**Part 1            ADDENDUM NO.3**

**Part 2            DRAWINGS – House V399**

INTERIOR/EXTERIOR RENOVATIONS - HOUSE 399  
ROOF PLAN  
DATE (YY MM DD) 17 07 18 SCALE AS NOTED  
CHECKED BY RS  
DRAWN BY RQS  
LOCATION HOUSE V399(BLUE) RESOLUTE BAY, NUNAVUT

**A1.3**

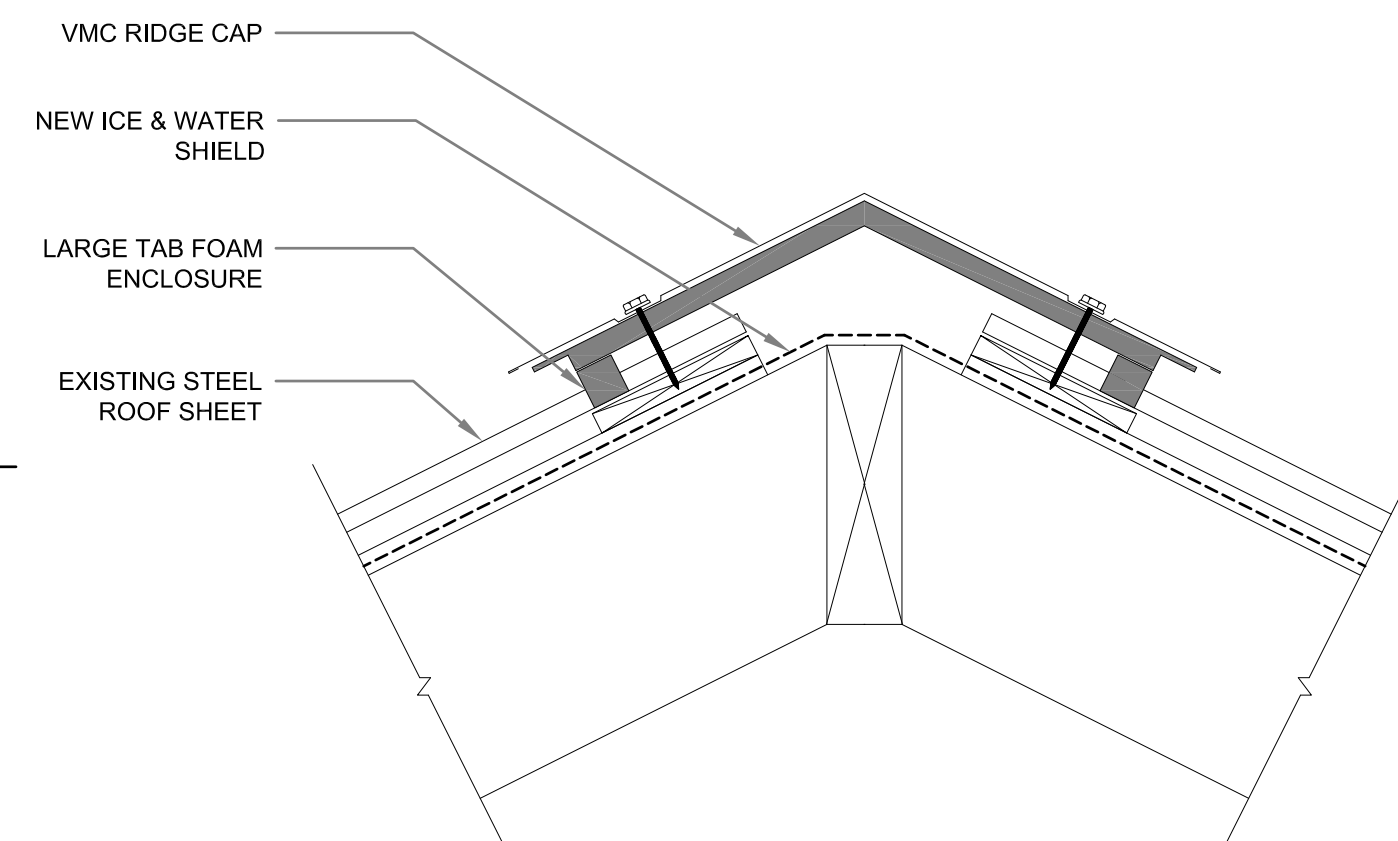
**2.1                Drawing A1.3 – Roof Plan**

- .1            Revised key notes and drawing notes see attached A1.3 Rev 01

1. SCREWS ARE MISSING IN SEVERAL PLACES. INSTALL NEW SCREWS AND GASKETS OVER ENTIRE ROOF.
2. CONTRACTOR TO REFASTEN ROOF (INSTALL NEW SCREWS; ADD END AND PEAK GASKETS; ADD ICE AND WATER SHIELD TO FIRST 4'-0" AT PEAK AND EAVE.
3. ADD NEW ROOF CAP.

PROJECT TITLE: INTERIOR/EXTERIOR RENOVATIONS - HOUSE 399  
SHEET TITLE: MECHANICAL PLAN  
DATE (YY MM DD): 17 07 18  
SCALE: AS NOTED  
DRAWN BY: RQS  
CHECKED BY: RS  
LOCATION: HOUSE V399(BLUE) RESOLUTE BAY, NUNAVUT

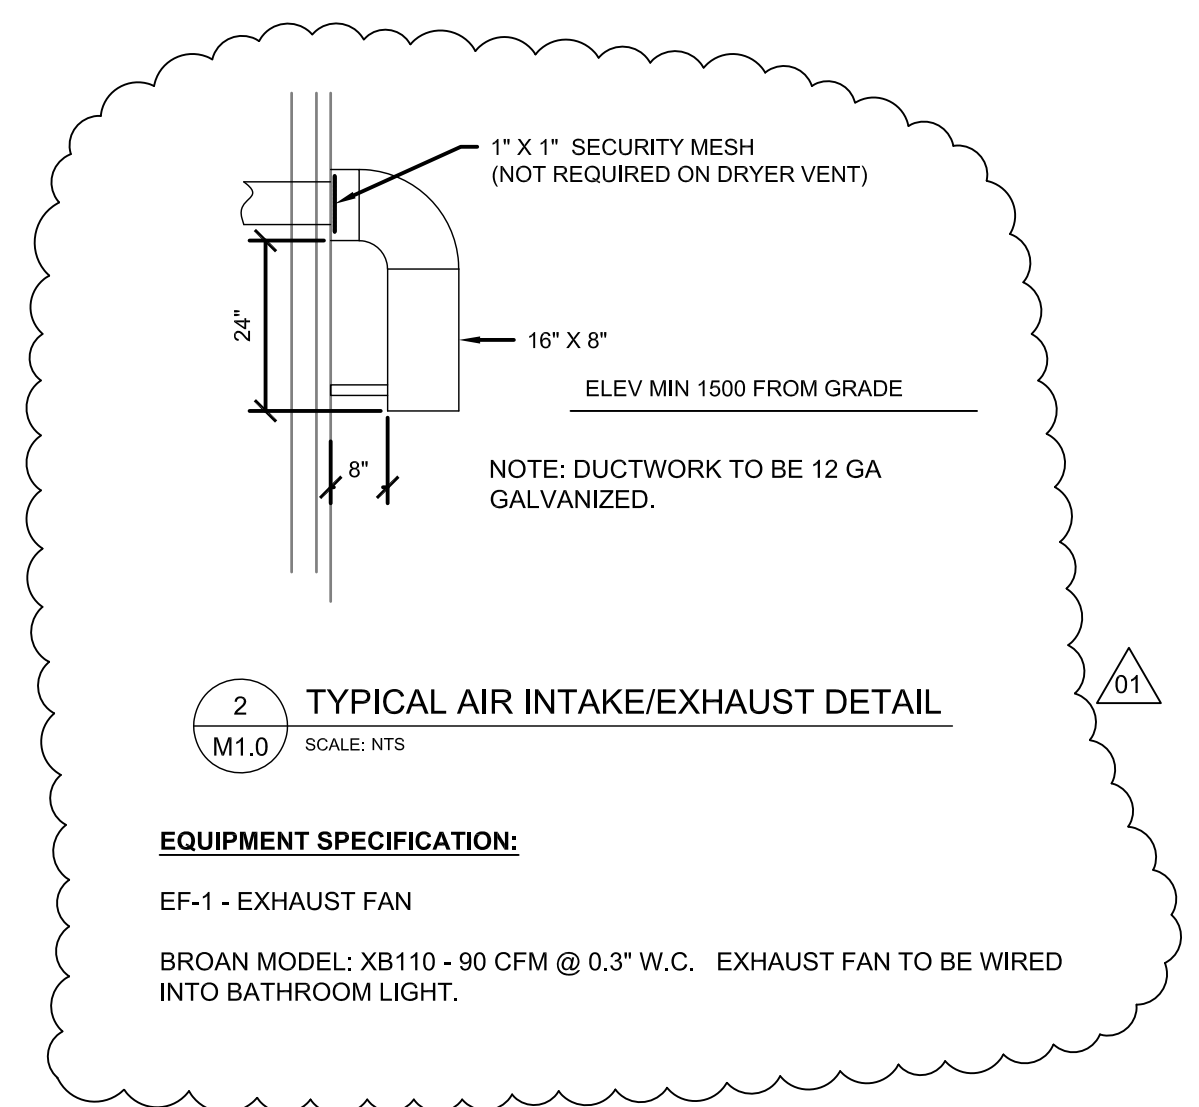
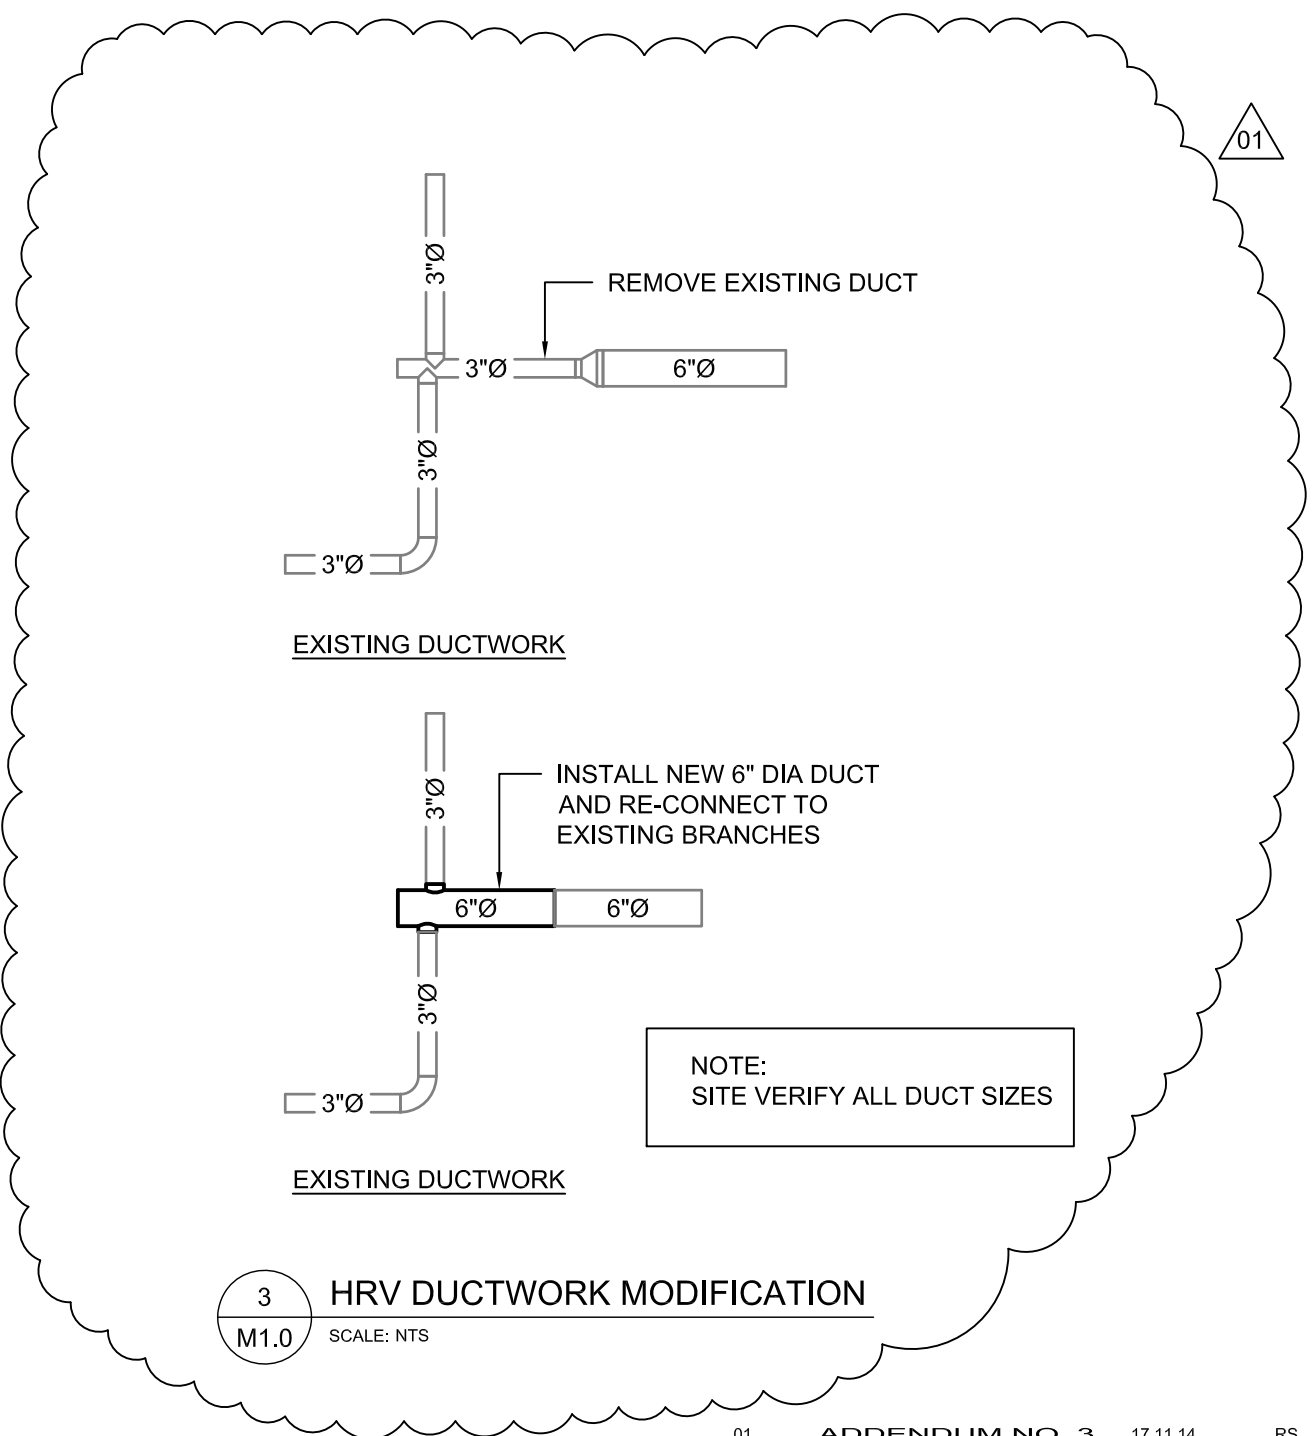
**2.2                Drawing M1.0 – Mechanical Plan**

- .1            Relocated EF-1 in bathroom no. 1
- .2            Added ductwork to HRV
- .3            Added Exhaust Fan Specification
- .4            See attached drawing M1.0 Rev 01

1. EXISTING HRV
2. EXISTING HUMIDIFIER
3. NEW LITTLE GIANT CONDENSATE PUMP. CONNECT TO EXISTING HRV AND HUMIDIFIER DRAIN. DISCHARGE TO EXISTING 3/4" TUBING.
4. NEW EXHAUST FAN. INSTALL IN NEW BULKHEAD WIRE TO LIGHT SWITCH.
- 01 5. NEW DUCT WORK TO EXTERIOR WALL. DUCTWORK TO BE INSTALLED ABOVE EXISTING T-BAR CEILING
6. NEW EXTERIOR EXHAUST HOOD SEE DETAIL 2 SHEET M1.0
7. INSULATE ALL HRV AND HUMIDIFIER DUCTWORK THAT IS ACCESSIBLE IN STORAGE ROOM. (SUPPLY AND EXHAUST)
- 01 8. NEW DUCTWORK TO BE INSTALLED TO EXTERIOR WALL. DUCTWORK TO BE INSTALLED IN NEW BULKHEAD
- 01 9. SEE DETAIL 3 FOR MODIFICATION TO HRV DUCTWORK.

**EQUIPMENT SPECIFICATION:**  
EF-1 - EXHAUST FAN  
BROAN MODEL: XB110 - 90 CFM @ 0.3" W.C. EXHAUST FAN TO BE WIRED INTO BATHROOM LIGHT.

PROJECT TITLE: INTERIOR/EXTERIOR RENOVATIONS - HOUSE 397  
SHEET TITLE: MECHANICAL PLAN  
DATE (YY MM DD): 17 07 18  
SCALE: AS NOTED  
DRAWN BY: RQS  
CHECKED BY: RS  
LOCATION: HOUSE V397 (RED) RESOLUTE BAY, NUNAVUT

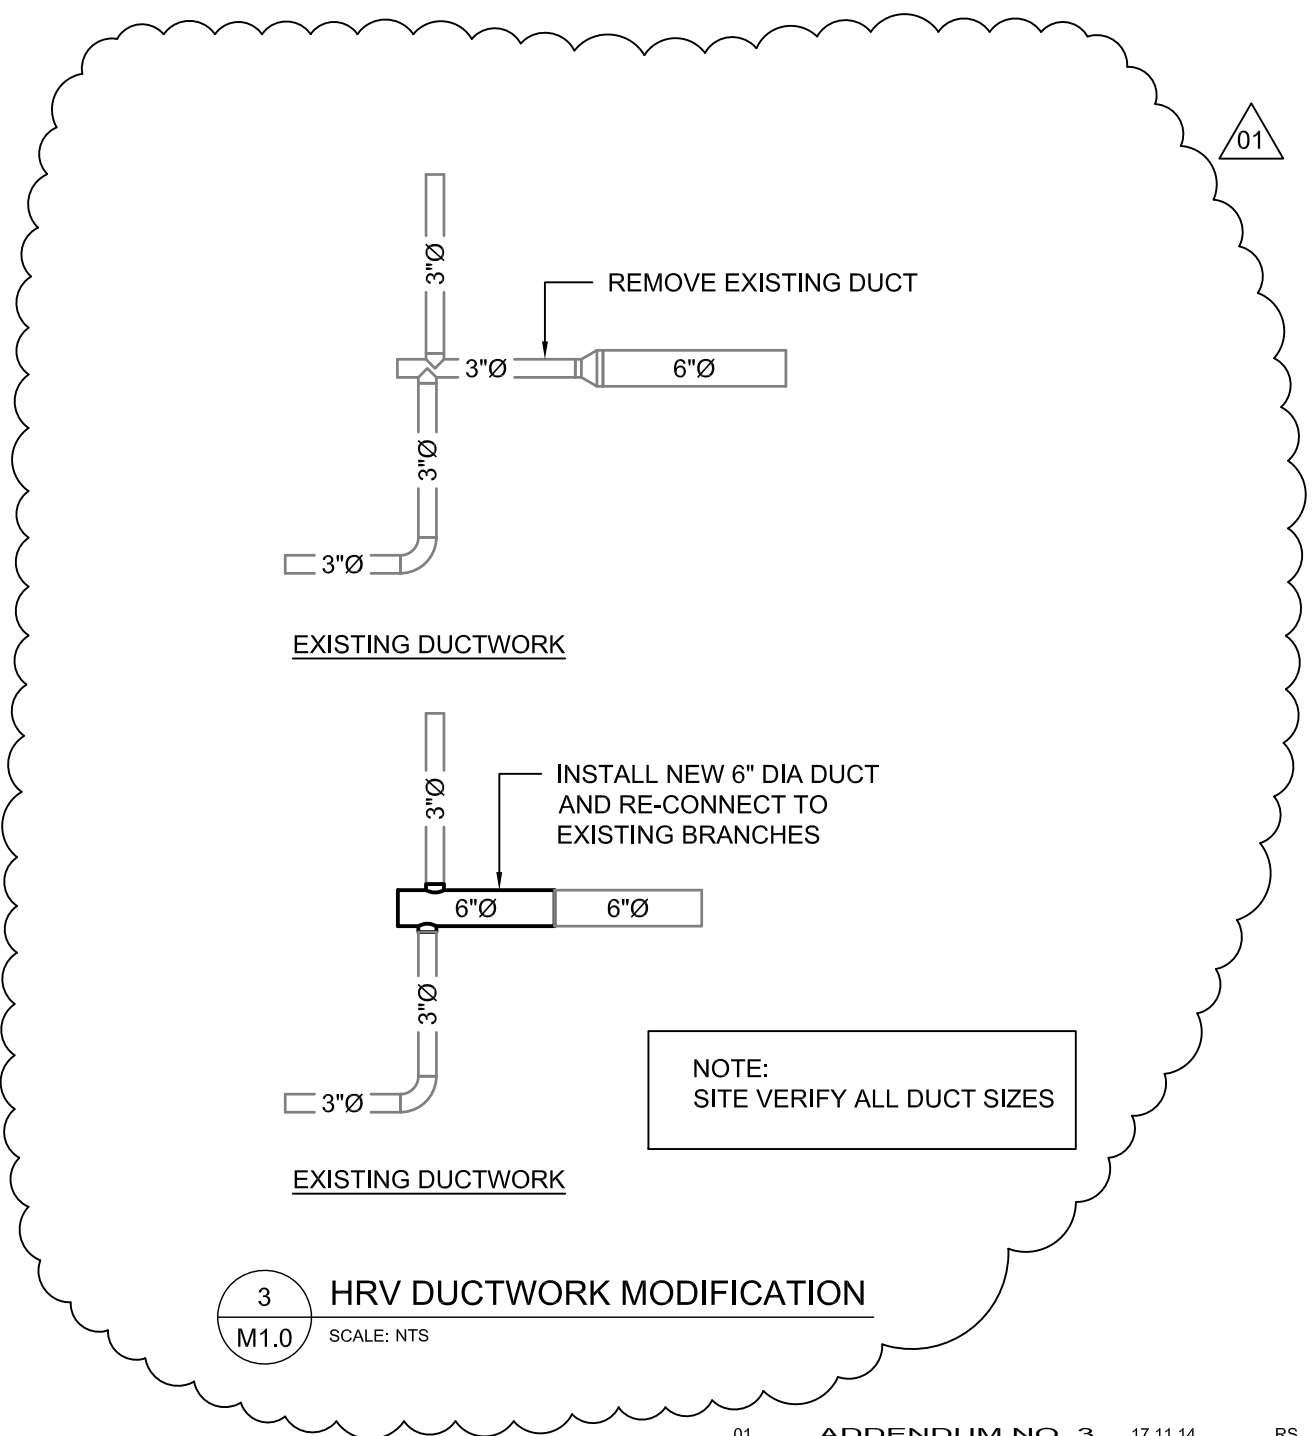
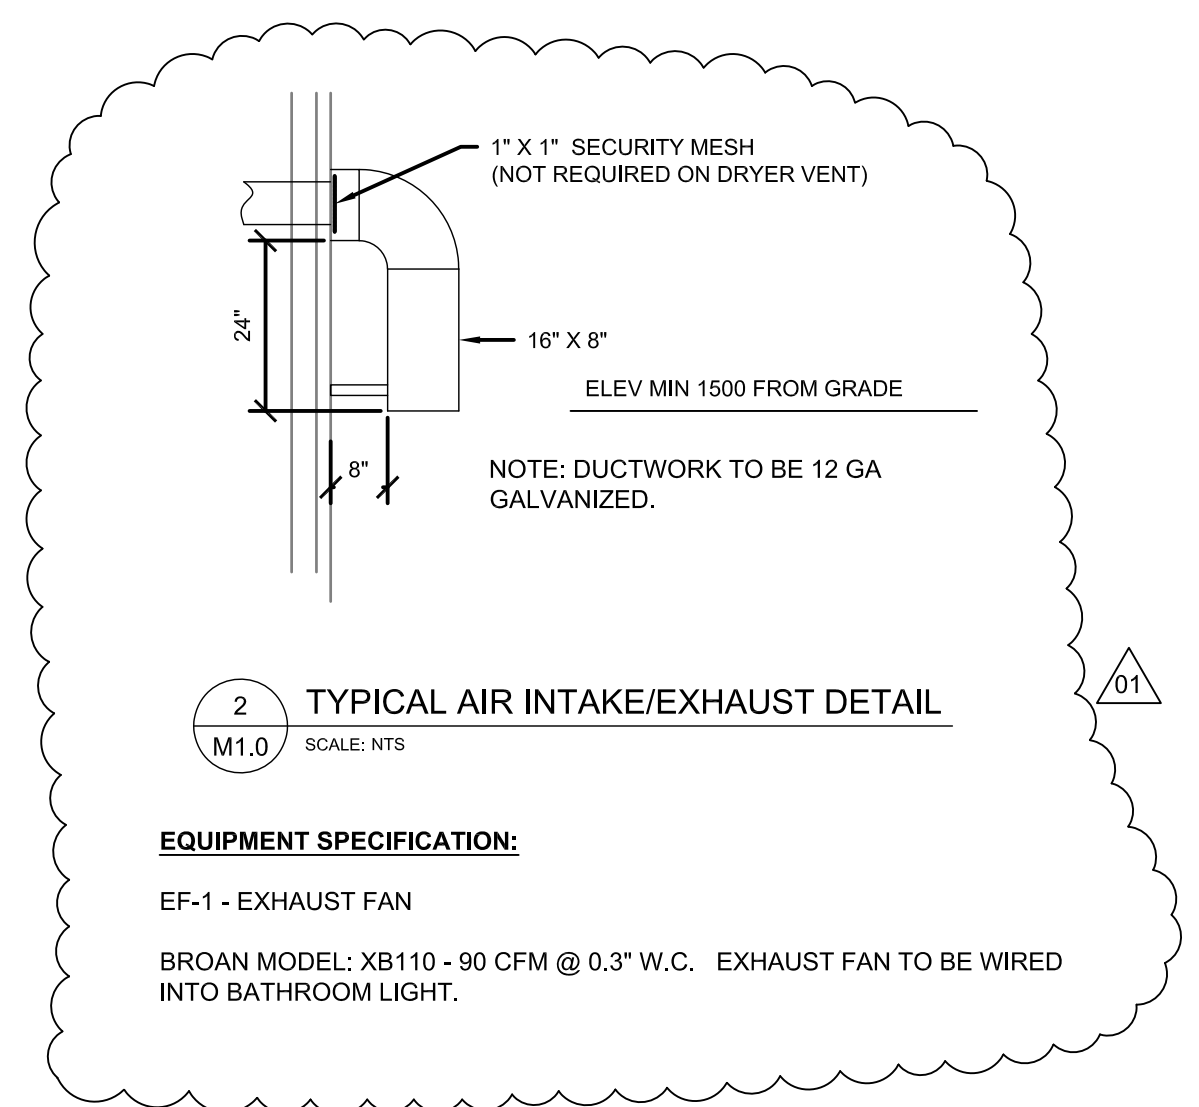
**3.1                Drawing M1.0 – Mechanical Plan**

- .1            Relocated EF-1 in bathroom no. 1
- .2            Added ductwork to HRV
- .3            Added Exhaust Fan Specification
- .4            See attached drawing M1.0 Rev 01

1. EXISTING HRV
2. EXISTING HUMIDIFIER
3. NEW LITTLE GIANT CONDENSATE PUMP. CONNECT TO EXISTING HRV AND HUMIDIFIER DRAIN. DISCHARGE TO EXISTING 3/4" TUBING.
4. NEW EXHAUST FAN. INSTALL IN NEW BULKHEAD WIRE TO LIGHT SWITCH.
- 01 5. NEW DUCT WORK TO EXTERIOR WALL. DUCTWORK TO BE INSTALLED ABOVE EXISTING T-BAR CEILING
6. NEW EXTERIOR EXHAUST HOOD SEE DETAIL 2 SHEET M1.0
7. INSULATE ALL HRV AND HUMIDIFIER DUCTWORK THAT IS ACCESSIBLE IN STORAGE ROOM. (SUPPLY AND EXHAUST)
- 01 8. NEW DUCTWORK TO BE INSTALLED TO EXTERIOR WALL. DUCTWORK TO BE INSTALLED IN NEW BULKHEAD
- 01 9. SEE DETAIL 3 FOR MODIFICATION TO HRV DUCTWORK.
